Planning Committee

28 February 2013

CHERWELL DISTRICT COUNCIL PLANNING COMMITTEE

WRITTEN UPDATES

APPLICATION
12/017521F

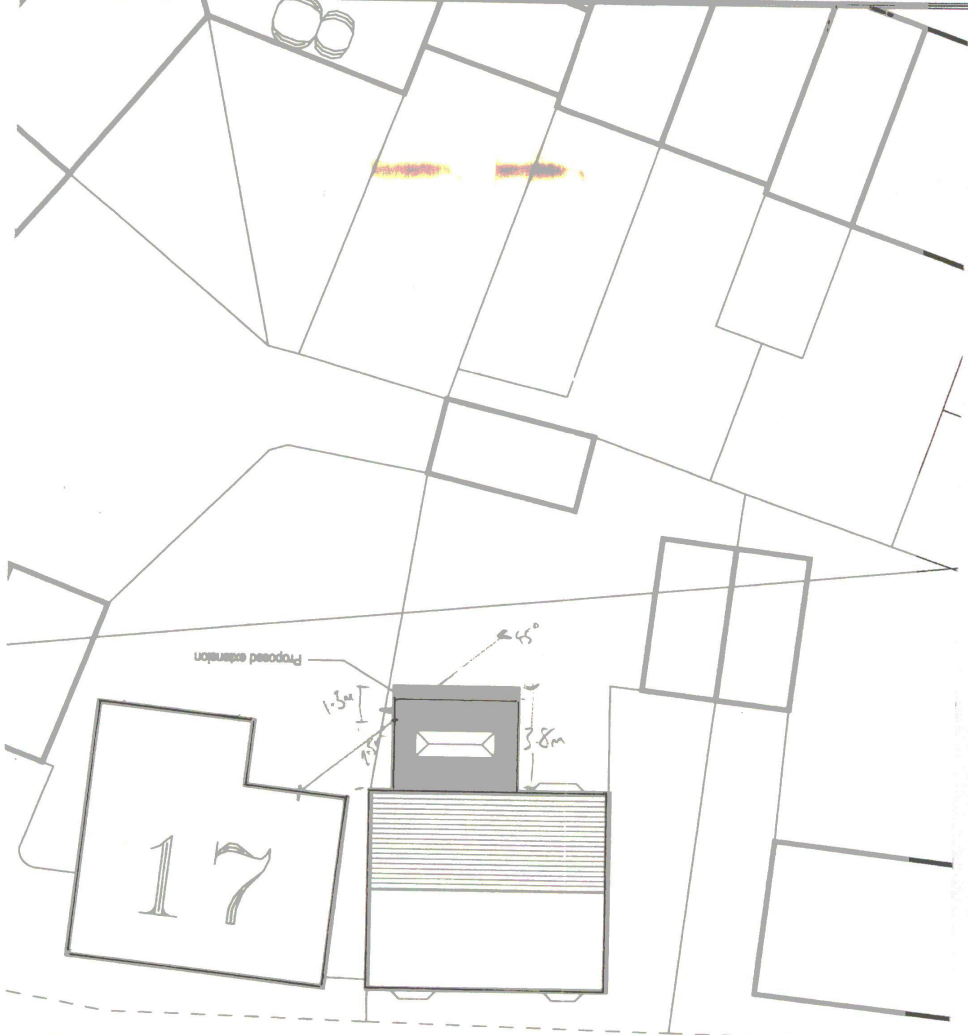
The original application was 3.9m in length, (not the 3.8, annotated)

Measuring the length of the extension taken from the intersection of the 45-degree angle to the rear elevation. It is 12mm. At a scale of 1:200 this is an actual length of 2.4 metres

Measuring from the intersection of the 45 degree angle to the end of the original extension, is 7mm equating to an actual measurement of 1.4m

The annotation by the previous planning officer gives measurements of 2.5 and 1.3, so there is not a great difference between the two sets of measurements

However, these measurements show that the proposed original extension as being at the *very least* 1.3 metres too long, possibly 1.4. The point at which the 45-degree angle intersects would remain at 2.5 m on *both the original and re-submitted application*. I do not believe that moving the extension further away by 10cm would significantly affect this. Therefore the original proposed extension should be, using this rule, a *maximum* of 2.5 m

Placed above this intersection is a thick vertical pencil line. I have no idea of its significance and can only guess

The re-submitted application is 3.4m in length. It is very important to note that it has only been fractionally moved by a mere 10cm further away from the boundary. This cannot have any significant effect on the use of the 45-degree rule. In fact using a scale of 1:200 it will scarcely be evident (0.5mm) on the re-submitted siteplan/block layout

I very carefully, using high-transparency art paper traced the new application plan. When placed over the original, using a scale rule the intersection of the 45-degree angle remains at between 12 and 13 mm representing a length of between 2.3 and 2.4m from the rear elevation of No 19
